ATTACHMENT 1: APPLICANT RESPONSE TO SRPP DEFERRAL REQUEST

RE: Response to Southern Regional Planning Panel deferral of DA 2023/849
Property: Lot 197 in DP1258914; Bong Bong Road, Huntley NSW 2530

Figure 1: Location of retaining walls at Site boundaries

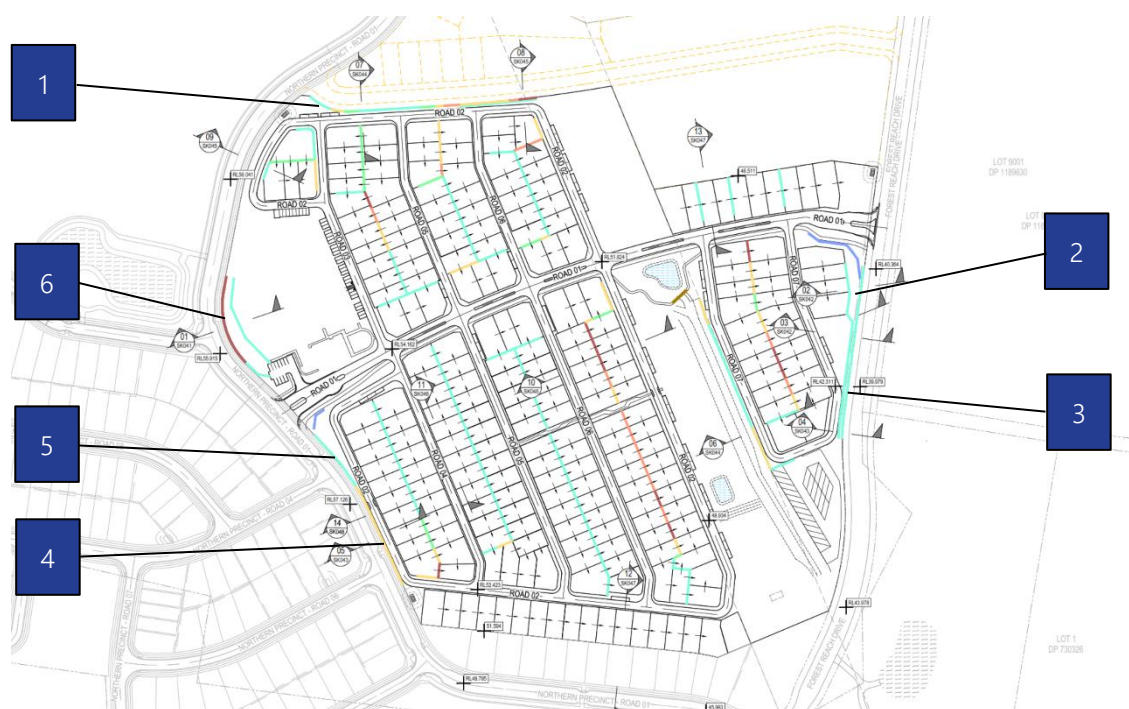
Along the northern boundary of the Site (Location 1 in **Figure 1**) the retaining wall ranges in height from 1m to 1.25m for the majority on the western side, before transitioning to 1.5m to east and up to 3m, for a limited length, at the interface with the TransGrid transmission line. At the eastern extent, the retaining wall will be terraced to manage the level change. This boundary will adjoin a future local road that will form part of Stage 8C, with the road sitting higher than the multi dwelling housing development and retaining wall not being visible from the public domain. This retaining wall is to be a split face or feature sleeper wall, located within the boundary of development with the ongoing ownership and maintenance the responsibility of the Applicant.

Below the eastern entrance to the development (Location 2 in **Figure 1**), a retaining wall in the order of 1.5m was proposed to manage level changes from Forest Reach Drive west to the TransGrid easement. Following review of the design in response to Council's report to the Panel, the opportunity to refine the retaining walls in this location was identified to reduce the direct interface and visual impact to Forest Reach Drive. As detailed in Figure 5, this wall is able to be replaced with a terraced retaining wall and landscaped batters. This would comprise of a 1m high wall at the boundary with Forest Reach Drive, with terraced landscape batter and 0.5m high wall at the rear of the dwellings. This will serve to remove significant bulk and scale from the retaining wall interface in this location. Refer to Section 2 on Sheet SK042 at **Attachment A**.

At the south eastern boundary of the Site with Forest Reach Drive (Refer to Location 3 in **Figure 1**), a retaining wall up to 2m in height, for approximately 65m, was proposed to transition levels between Forest Reach Drive and the TransGrid easement to the west. Similar to the above discussion, the retaining wall in this location is able to be designed to accommodate a terraced sandstone block wall reduce the direct interface and visual impact to Forest Reach Drive. Refer to Sections 3 and on Sheets SK042 and SK043 at **Attachment A** and **Figure 6**. Walls of this scale and interface with local roads have been approved by Council in similar greenfield release areas in Wollongong City Council including Wombarra, Wongawilli and Norman estates, refer to example at **Figure 7** that would be indicative of the outcome that would be delivered along Forest Reach Drive.

Further south of the western entrance (Location 4 in **Figure 1**) levels over the Site fall away to assist in the overall transition of easter/west fall over the Site with the Northern Precinct Road No. 1 sitting above the development levels. At this location, pedestrians along the Northern Precinct Road No. 1 would be looking down to the development and front facades of dwellings not dissimilar to a standard residential development that provides a slip road to a higher order road like Northern

South of the western entrance (Location 5 in **Figure 1**), retaining walls are more of a landscape intervention to compliment the entry feature. Limited to 1m in height with open blade fencing that is integrated within the landscape design, this wall is not considered to have any significant impacts to the public domain and typical of other greenfield developments. Refer to **Figure 9** for a render of the western entry.

To the north of the western entrance (Location 6 in **Figure 1**), the road sits higher than the adjoining retaining wall that is used to form a stormwater management swale that will present not dissimilar to other pieces of landscaped stormwater infrastructure approved by Council before transitioning to the Community Buildings proposed in DA-2024/202. Refer to **Figure 10** for a typical basin outcome in this location and section of the wall at **Figure 11**. This interface is considered to be appropriate in a new release setting where it is a common occurrence for interfaces with stormwater management infrastructure, with the benefit that it will be the operator maintaining the landscape in this area compared to Council's often constrained maintenance.
